AGENDA

WARRENTON PLANNING COMMISSION
Regular Meeting | November 10, 2022 | 6:00pm
Warrenton City Hall Commission Chambers | 225 S Main Avenue, Warrenton, OR 97146

TO: The Warrenton Planning Commission  
 FROM: Jay Blake, Planning Director   
 DATE: November 10, 2022  
 SUBJ: SUB 22-02: Buoy 10 Land Preliminary Plat  
 Nathan Johnson, Sunrise Homes, Inc.  
 Tax Parcel: 81009BC01100

COMPOSITE SITE & UTILITY PLAN  
SUNRISE HOMES-7 LOT SUBDIVISION  
354 PACIFIC DRIVE, WARRENTON, OR 97146

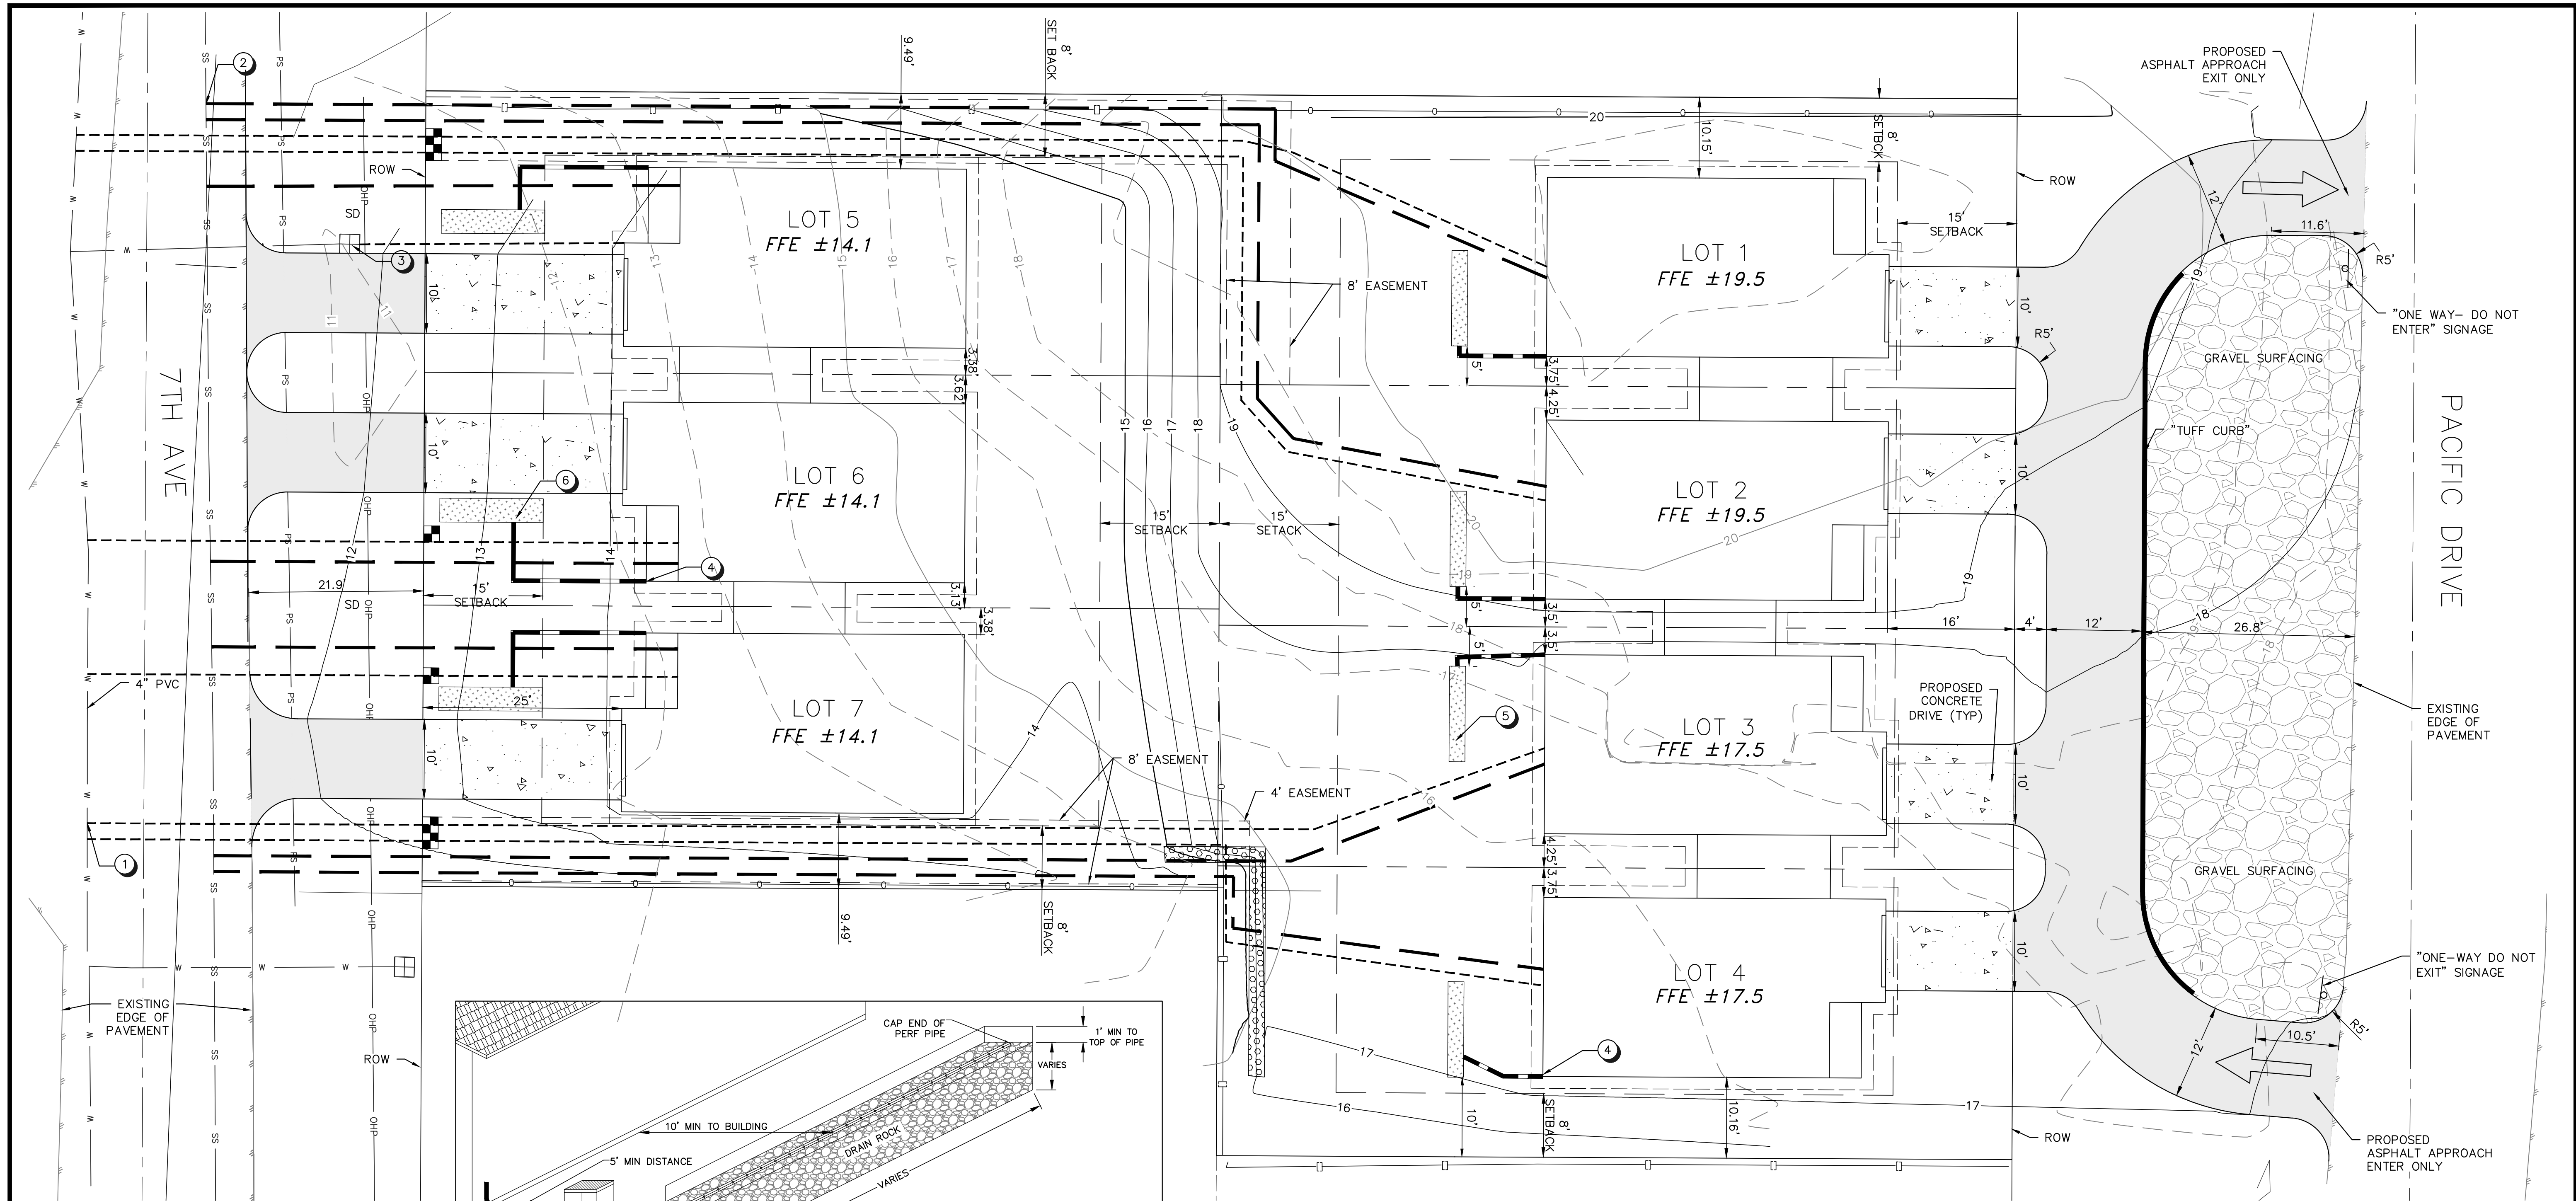
- Initial engineering comments address the need to include all impervious coverage in stormwater management plans, including driveways and sidewalks. This should be addressed prior to final plat approval.
- Additional comments about stormwater planning are included in the engineering comments that were provided to the applicant.

- All final plans need to meet the requirements of the Warrenton Municipal Development Code and Engineering design standards.
- Engineering recommends that sidewalks be installed along both Pacific Drive (ODOT) and Seventh Avenue (City). *Pacific Drive is a Major Collector and Seventh Avenue is a Minor Collector according* to the Transportation System Plan. The applicant is proposing a sidewalk in-lieu payment.
- The applicant shall confirm shared driveway design approval with ODOT. The driveways should also meet size and separation requirements.
- Stormwater plans should address all run-off including driveways, this may require additional design and improvements adjacent or in public right-of-way. *The applicant has stated that they will design stormwater improvements to take surface water flow from a portion of Seventh Avenue and driveways.*

- The site plan should include the location of a fire hydrant located within 250 feet of the buildings as required by the Fire Code. The applicant shall confirm that adequate flows exist to meet fire flow needs. *(See the additional comments from Fire Chief Brian Alsbury below).*

- *The Warrenton Fire Chief, Brian Alsbury has reviewed the proposal and measured the distances from three nearby fire hydrants. He concluded that no new fire hydrants are needed. He concluded that the location of existing hydrants and the sprinkling of the structures will provide adequate fire protection. A copy of his correspondence is in the file.*
